L-2012-031  
10 CFR 52.3

Re: Florida Power & Light Company  
Proposed Turkey Point Units 6 and 7  
Docket Nos. 52-040 and 52-041  
Response to NRC Request for Additional Information Letter 1112081  
(RAI 5765) Related to ESRP Section 4.2 – Water-Related Impacts

**NRC RAI Letter 1112081 Dated December 8, 2011**

**SRP Section: EIS 4.2 – Water-Related Impacts**

**Turkey Point Plant Property and Vicinity Aerial Photograph (12/27/1963)**

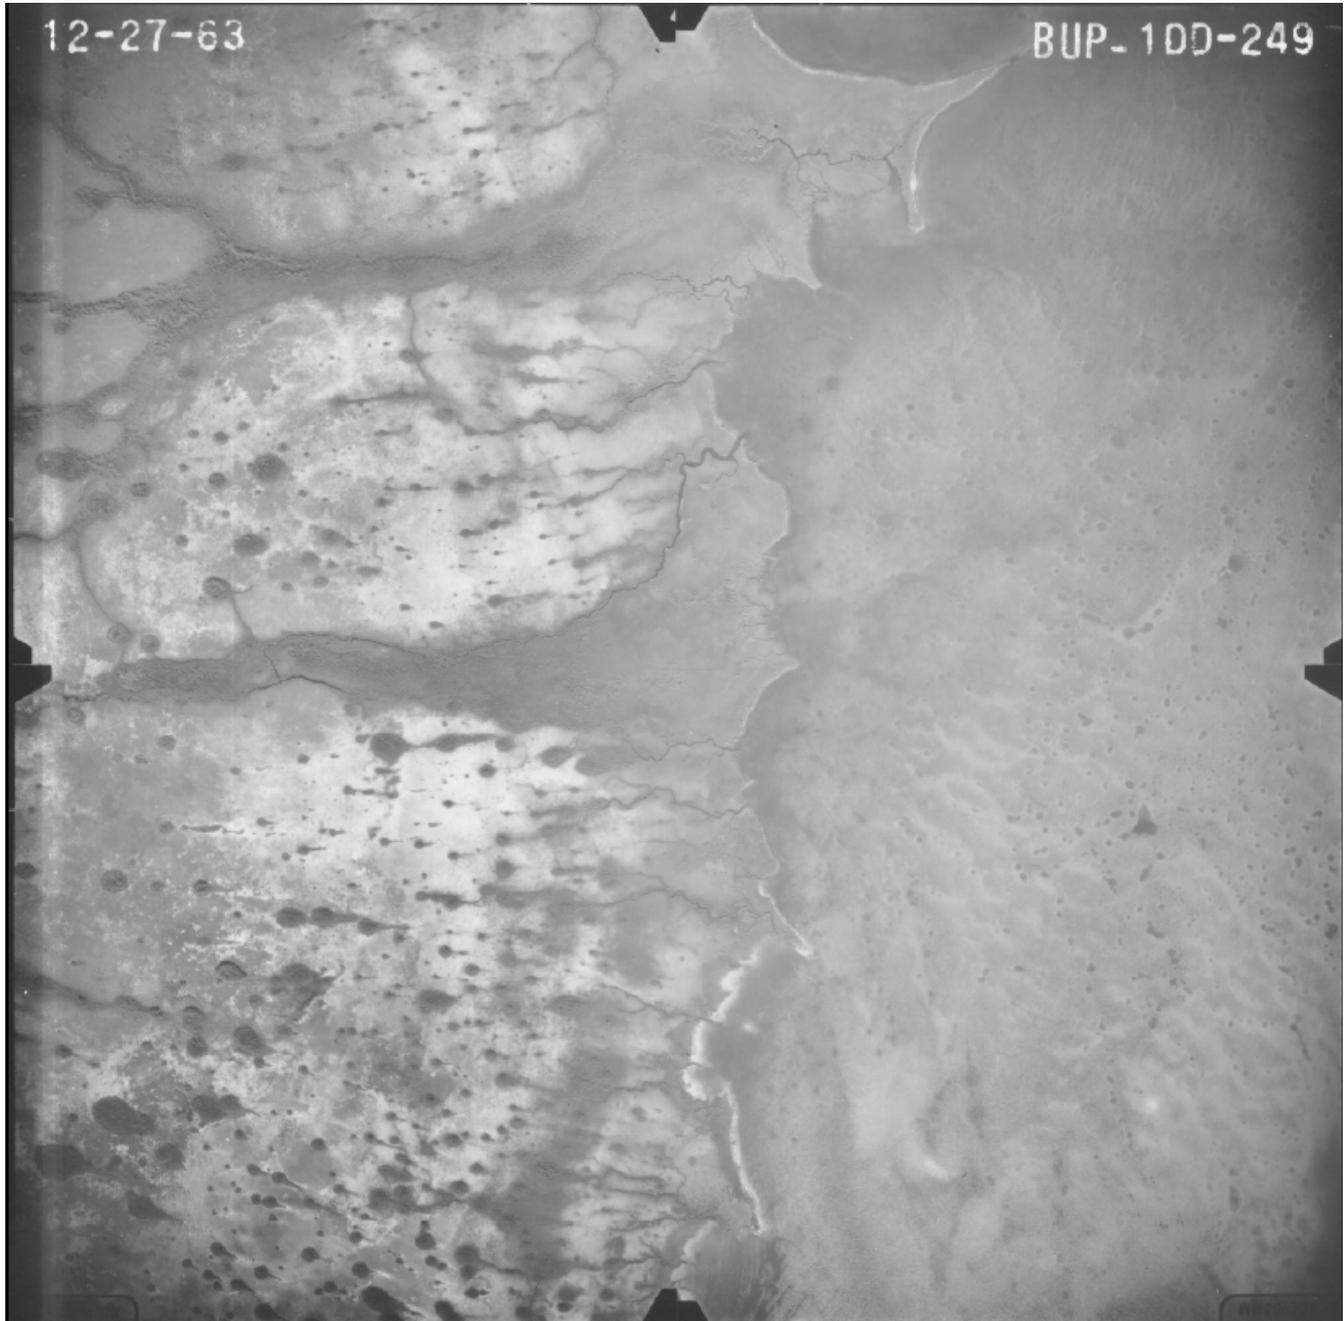
Characterize the typical sedimentation rates and transport patterns along the shoreline of the Turkey Point Peninsula. Explain how sedimentation patterns will change locally due to coastal construction, including, but not limited to, dredging needed for the barge-turning basin and the emplacement of pipelines along the coast. In addition, provide an aerial photo prior to the original plant's construction (preferably early 1960's) which includes the Turkey Point Peninsula and coastal Biscayne Bay near the plant, including the barge turning area.

Aerial photographs including the Turkey Point plant property and vicinity (1963) have been included in Sheets 1 and 2.

**Figure 1**  
**Post-Construction Recharge Zones (FPL, 2011b)**

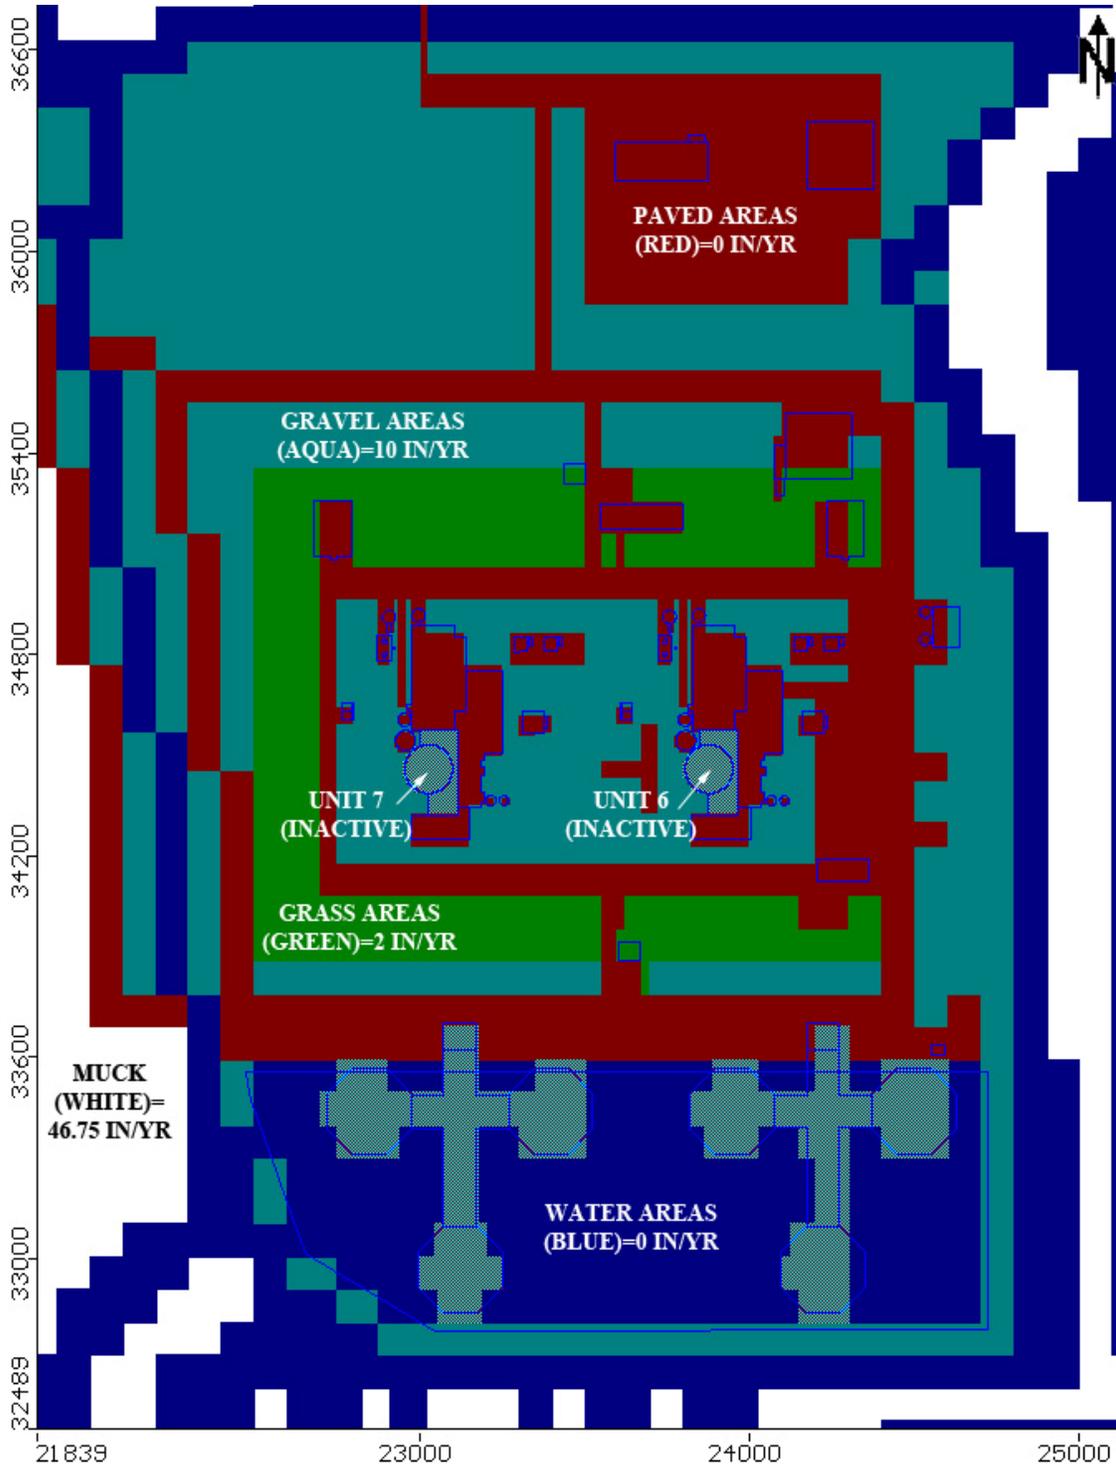
The construction of the proposed Units 6 and 7 will significantly alter both the surface and subsurface permeabilities of the site. Structures and paved areas will provide impervious surfaces that will preclude recharge. Unpaved areas may see either reduced or enhanced recharge. Deeply embedded structures, fill material, grouting, etc will alter the subsurface permeabilities. Provide an explanation of the changes in subsurface flow (spatial distribution of flows in terms of velocities.) beneath the site from the current condition to the post construction condition. Identify land covers expressed in terms of recharge properties over the entire site. Describe any potential changes in the subsurface movement of the hypersaline waters beneath the cooling canals.

The post-construction groundwater flow model presented in FPL 2011b includes spatially distributed recharge as presented in Figure 1. The post-construction land cover on the island includes: inactive to flow, surface water, paved, grass, and gravel areas (all muck is removed from this area during construction). The inactive-to-flow areas represent plant structures. Recharge rates for the surface water, paved, grass, and gravel areas were set to 0, 0, 2 and 10 in./yr, respectively, as discussed in FPL 2011a. In the model, approximately 44 percent of the island receives 0 in./yr of recharge, 11 percent receives 2 in./yr of recharge, 38 percent receives 10 in./yr of recharge, and 6 percent of the island land cover is inactive to flow (FPL, 2011b).
